Figure QF-463
Bend Test Specimen Removal, Configuration, and Testing (Cont'd)

NOTE TO EDITOR: Replace Figure QF-463, illustration (d) with the jpeg file, taken from ASTM F3183, shown on page 4 of this handout.

(d) Guided Side-Bend Test Machine Dimensions

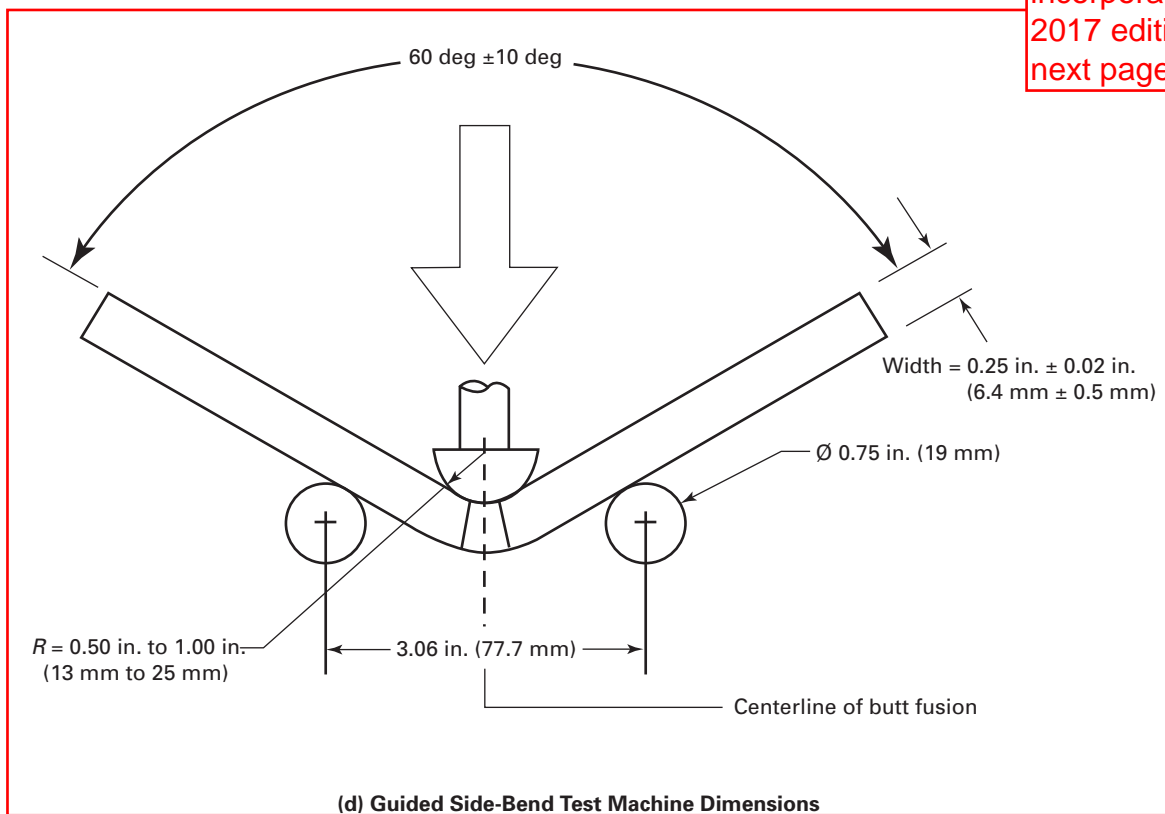
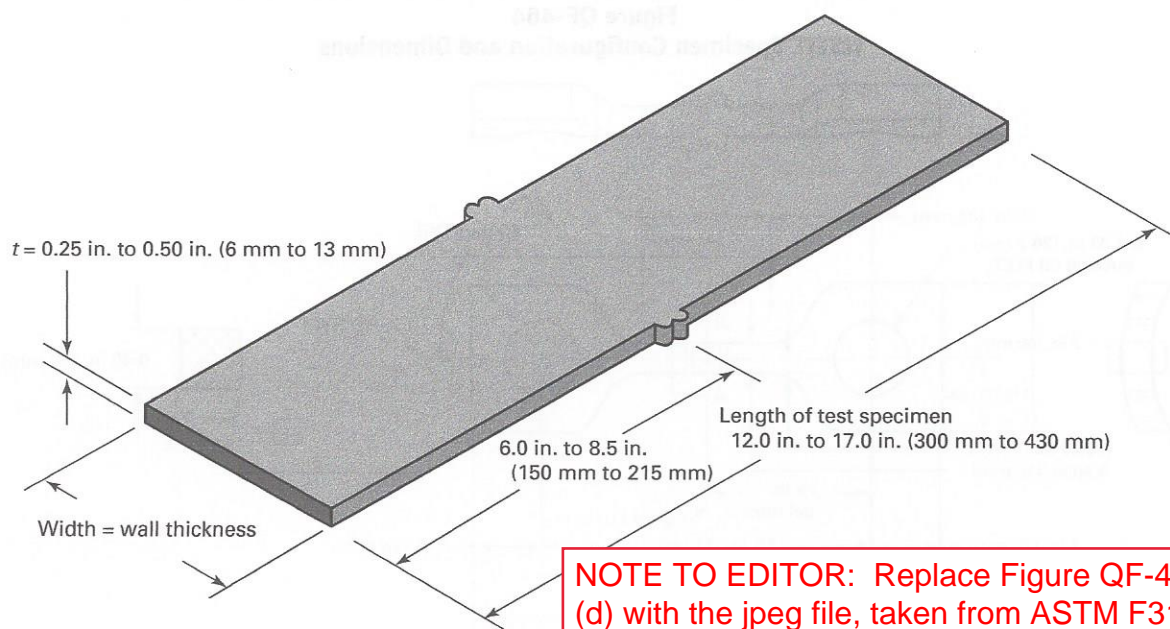
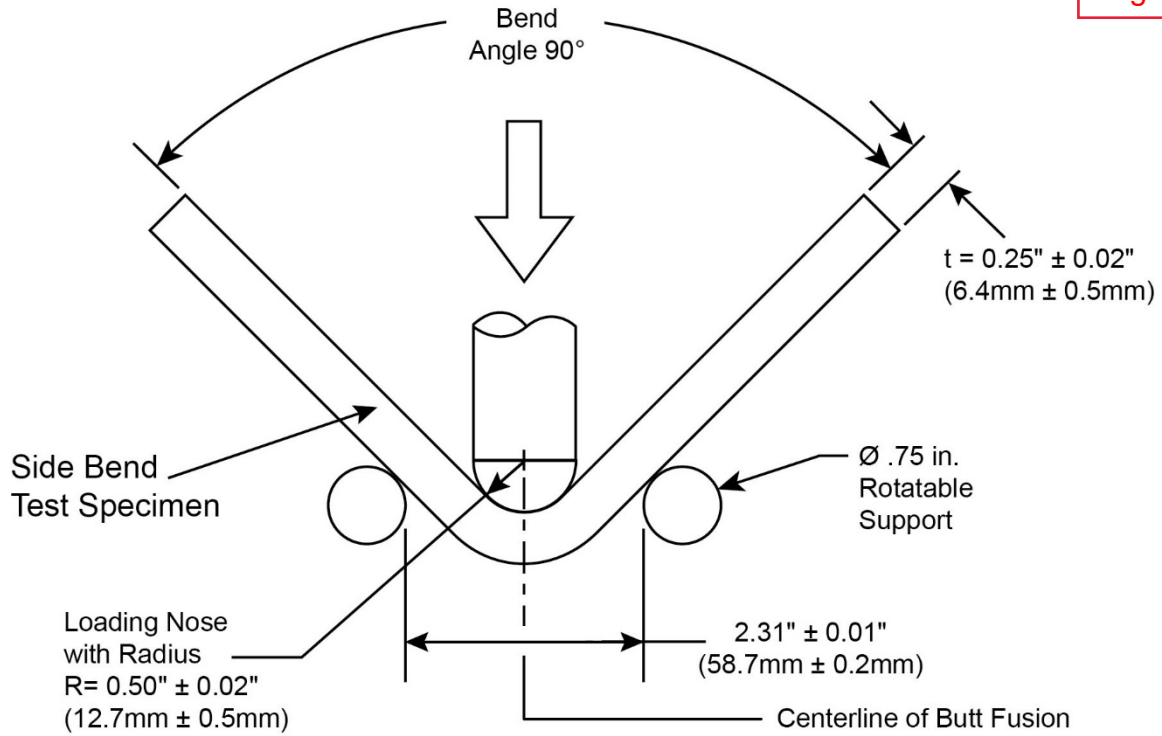
Fig. QF-463(d) was revised under record# 13-467 and should have been incorporated in 2017 edition, see next pages
